Re: Second Submission Review: Parklands Village 1 Phase 2 – Site Plan and Plat
Application Number: DA-2289-06
Case Numbers: 2024-4015-00; 2024-3028-00

PARKLANDS VILLAGE 1 SITE PLAN NO. 2

PARKLANDS VILLAGE 1 SUBDIVISION FILING NO. 2

SHEET 1 OF 6

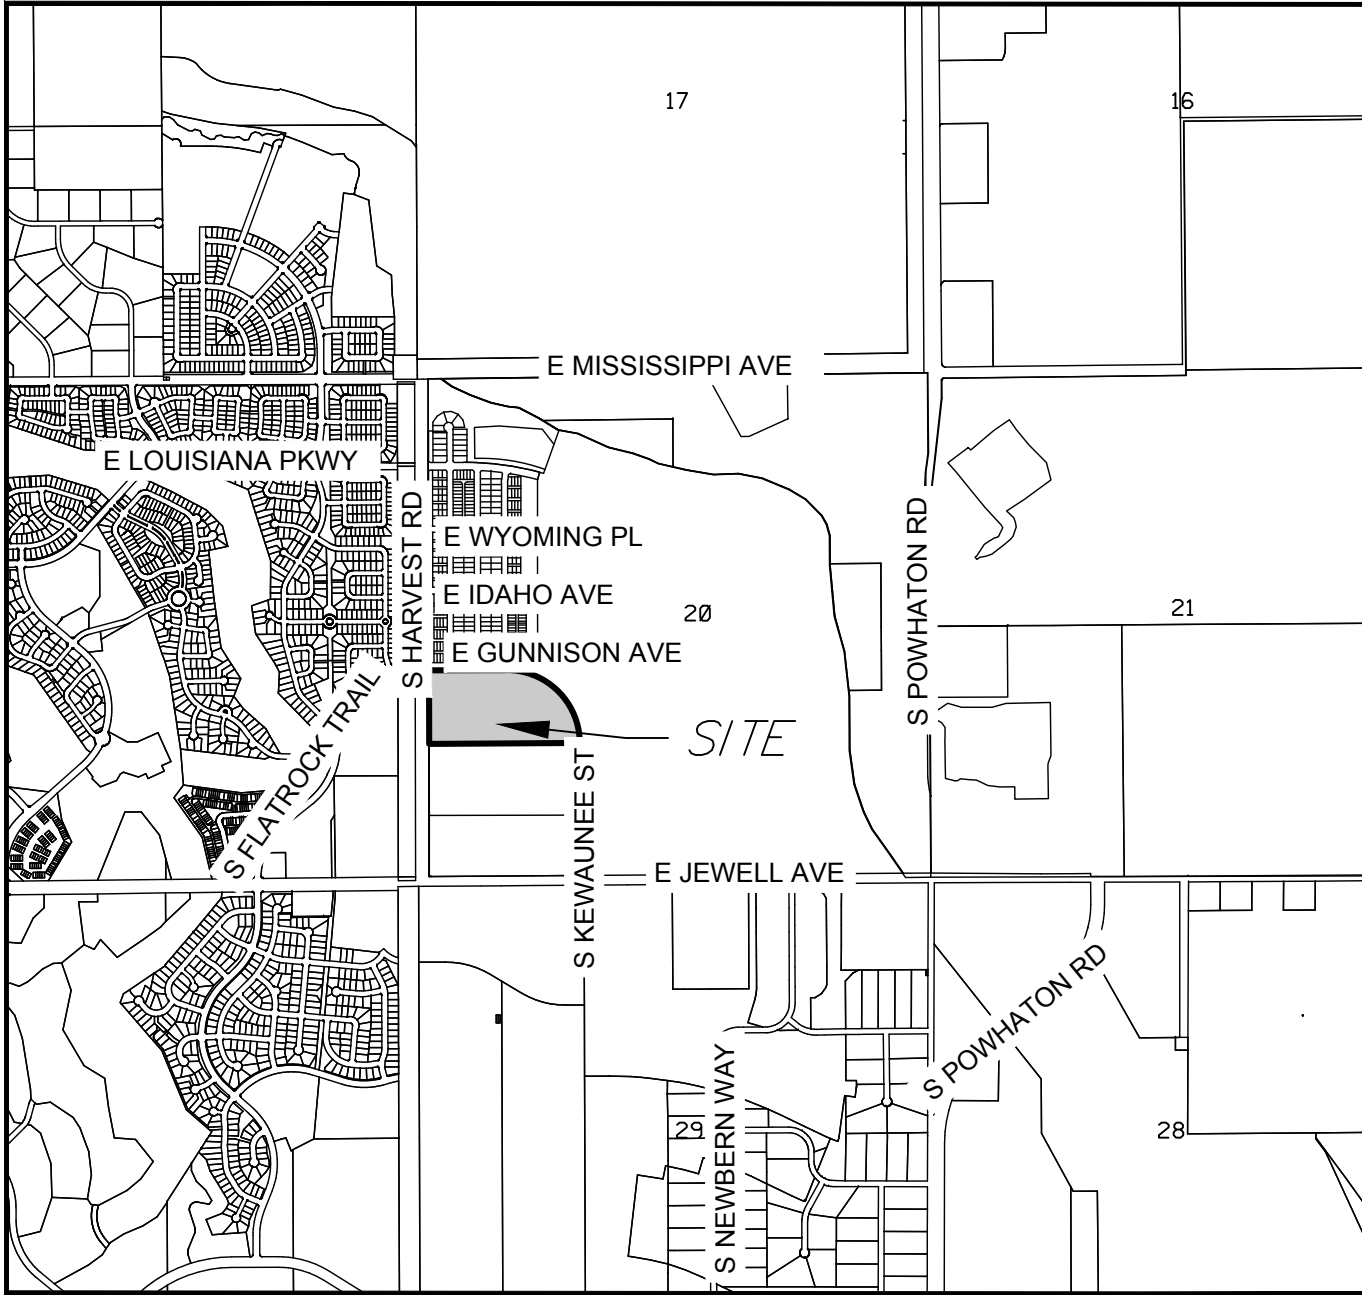
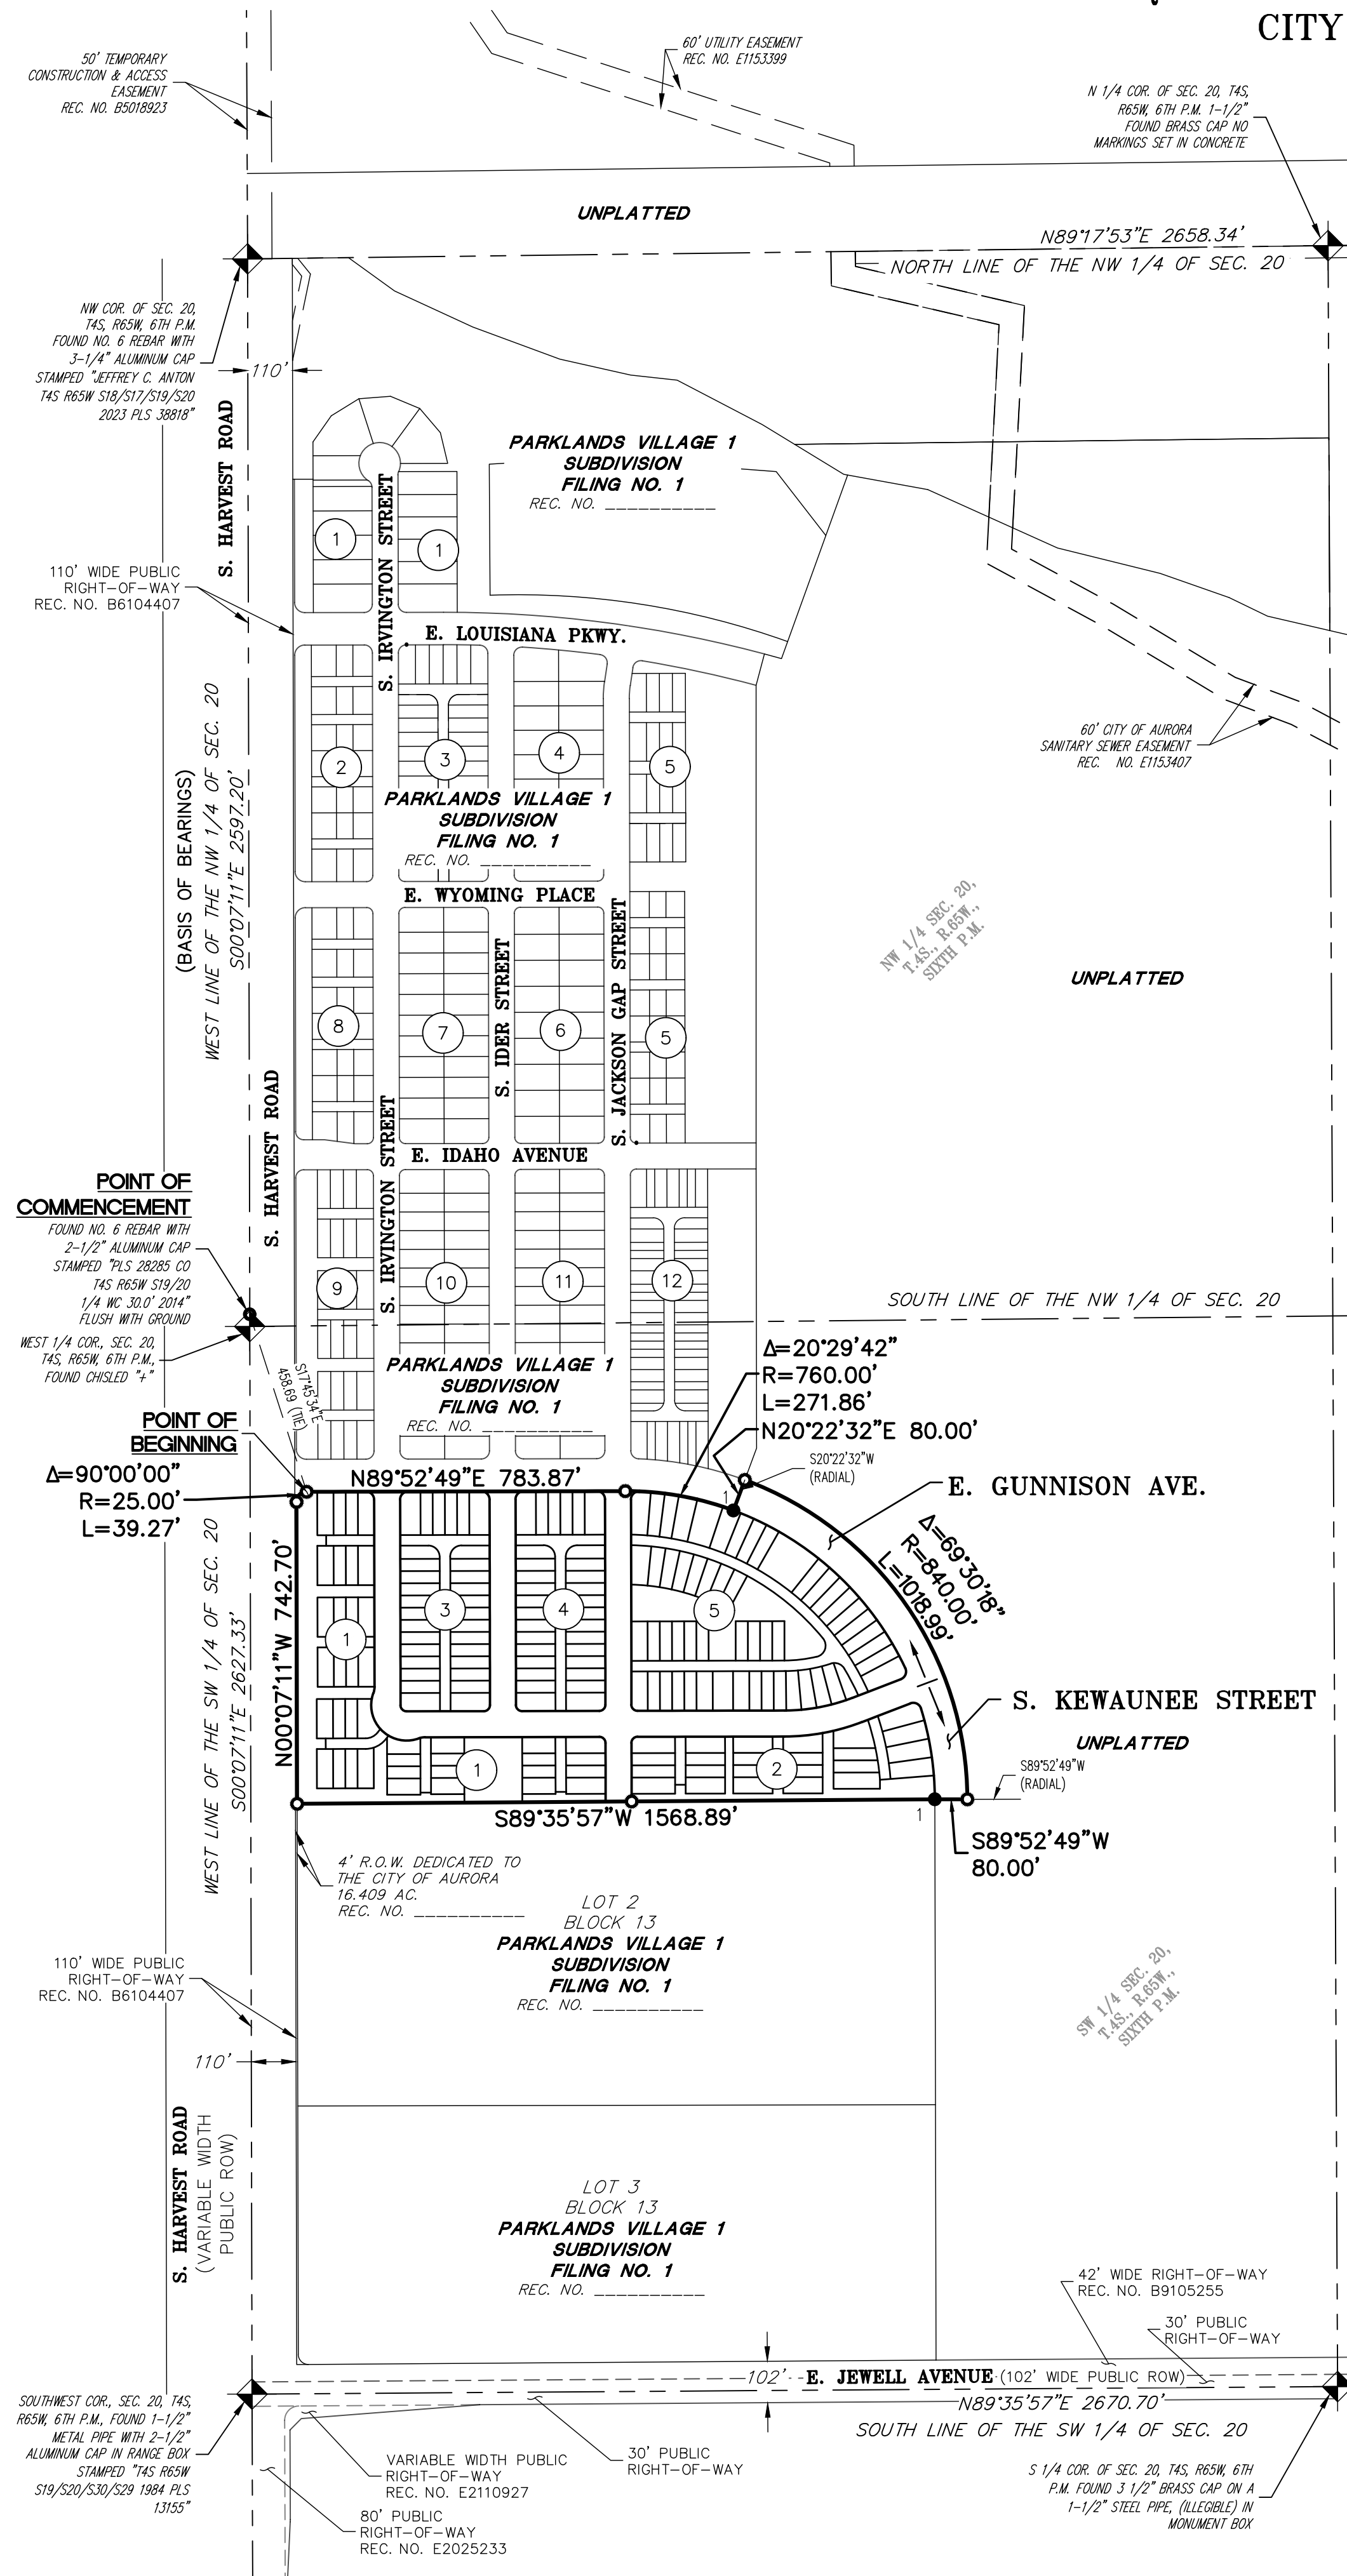
Add covenant for Sanitary Sewer Easement, Storm Sewer Easement and Water Easement (Referenced on Sheet 3)

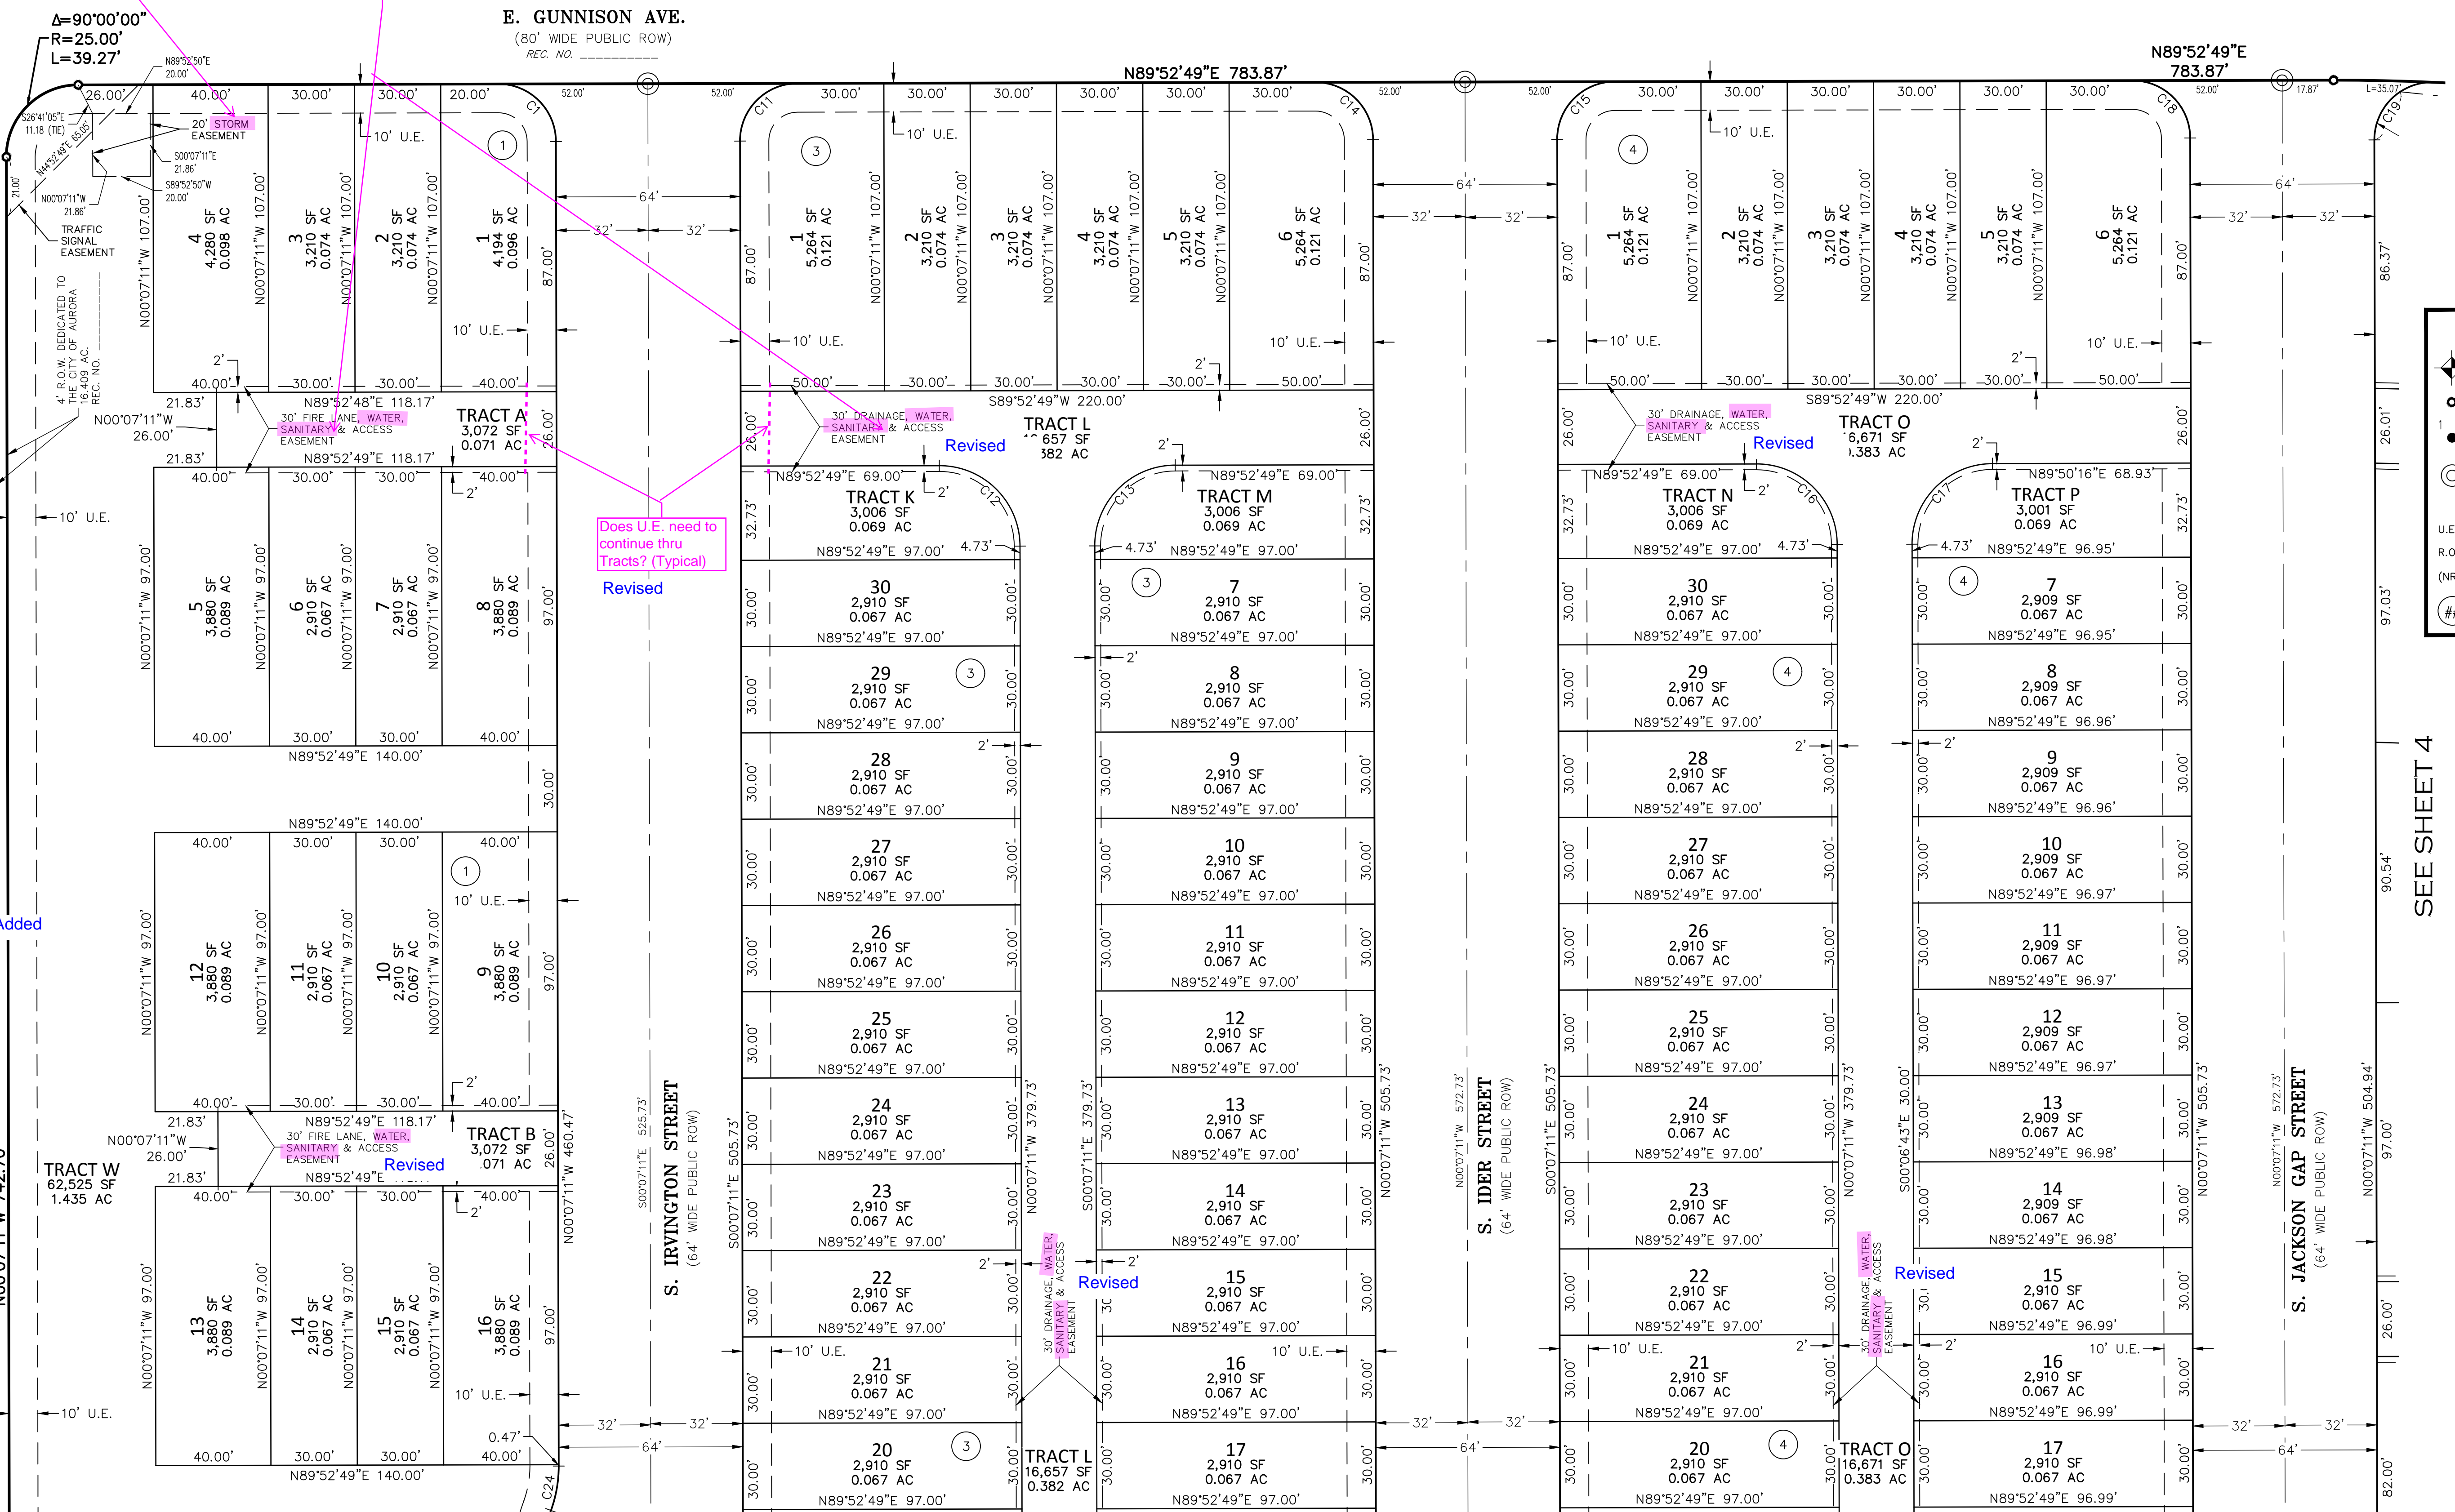
STORM SEWER?
[Typical]
(Add covenant for Storm Sewer
Easement on Sheet 1)

SANITARY SEWER?
[Typical]
(Add covenant for Sanitary Sewer Easement
and Water Easement on Sheet 1)

Revised

Revised
